NCPC File No. 6132

PENNSYLVANIA AVENUE IN FRONT OF THE WHITE HOUSE SECURITY AND LANDSCAPE IMPROVEMENTS

CONCEPT DESIGN

STAFF RECOMMENDATION

17th Street Barrier Detail

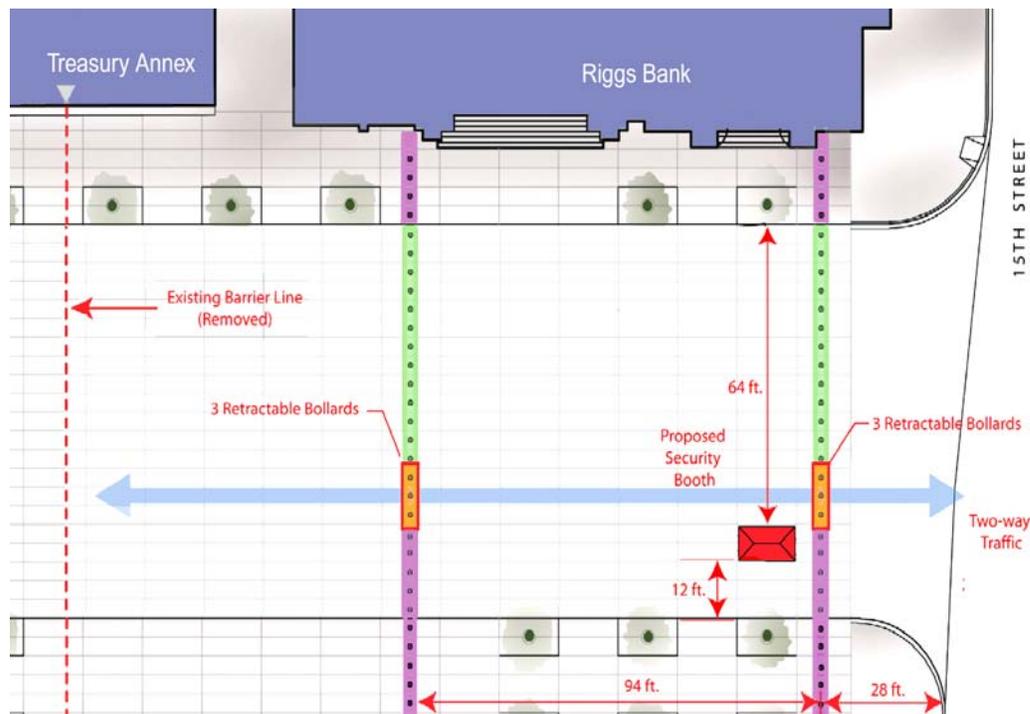
- Further evaluating the setback of the outer bollard lines on 15th and 17th Streets to accommodate cueing vehicles and a drop-off location without interfering with the pedestrian crosswalk.

- Further evaluating the setback of the outer bollard lines on 15th and 17th Streets to accommodate cueing vehicles and a drop-off location without interfering with the pedestrian crosswalk.

17th Street and Pennsylvania Avenue barrier line interface

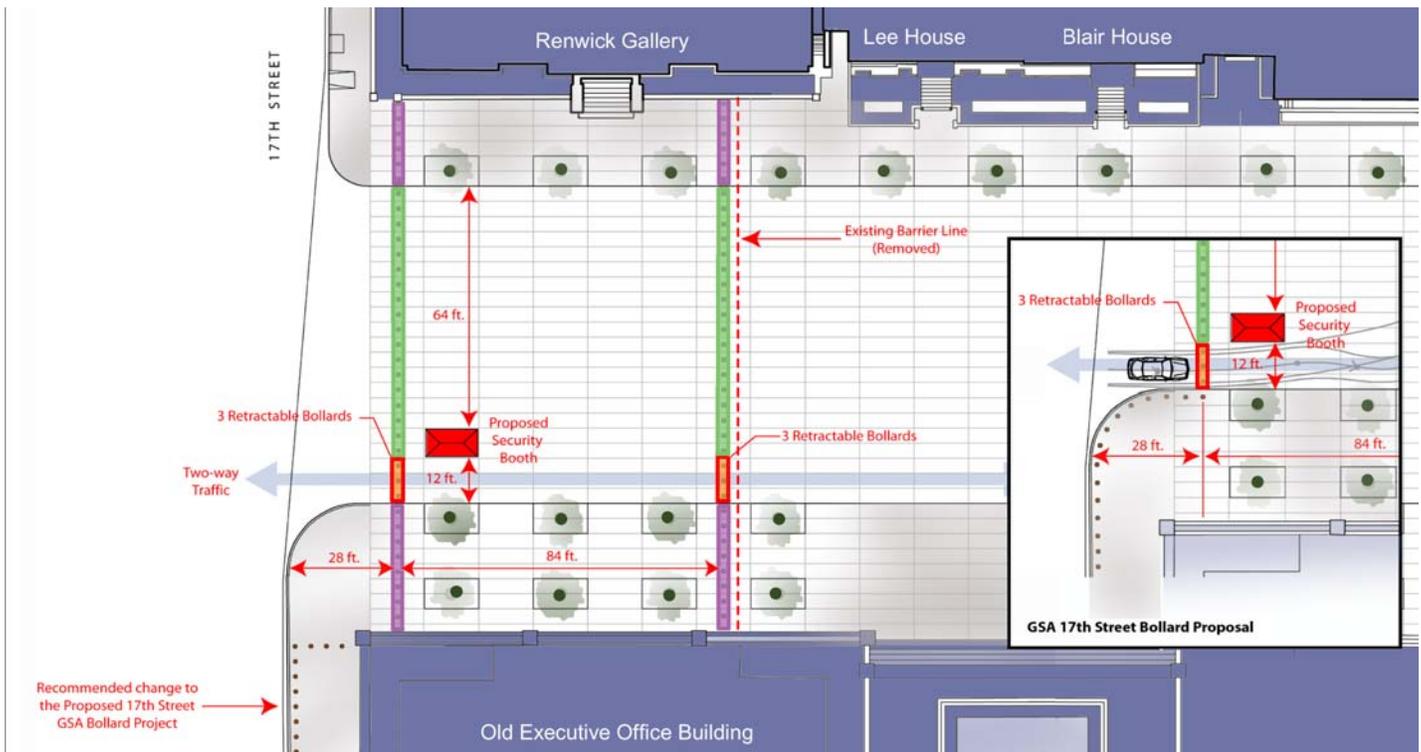
- GSA is currently installing bollards along the curb of 17th Street as an extension of the Southside Barrier Project, and is working under an aggressive construction schedule. The GSA and NCPC approved bollard line extends up the 17th Street sidewalk and follows the curb of the intersection to connect with the proposed Pennsylvania Avenue security line (See illustration on the following page).

The proposed concept design for Pennsylvania Avenue includes a different bollard configuration line at 17th Street. Instead of stopping at the curb to connect with GSA's proposed bollard line, the proposed Pennsylvania Avenue bollard line extends across the sidewalk to the EEOB fence. The purpose of this configuration is to improve both the aesthetic and functional design of the Pennsylvania Avenue barrier line. Therefore, if approved, the proposed project will modify the previously approved 17th Street bollard line. **This design detail will require further evaluation and coordination as design development proceeds. Staff recommends that the Commission delegate authority to the Executive Director to work with the General Services Administration to modify the previously approved bollard configuration at the intersection of 17th Street and Pennsylvania Avenue to better coordinate with this design concept and avoid disruption to the 17th Street bollard project construction schedule.**
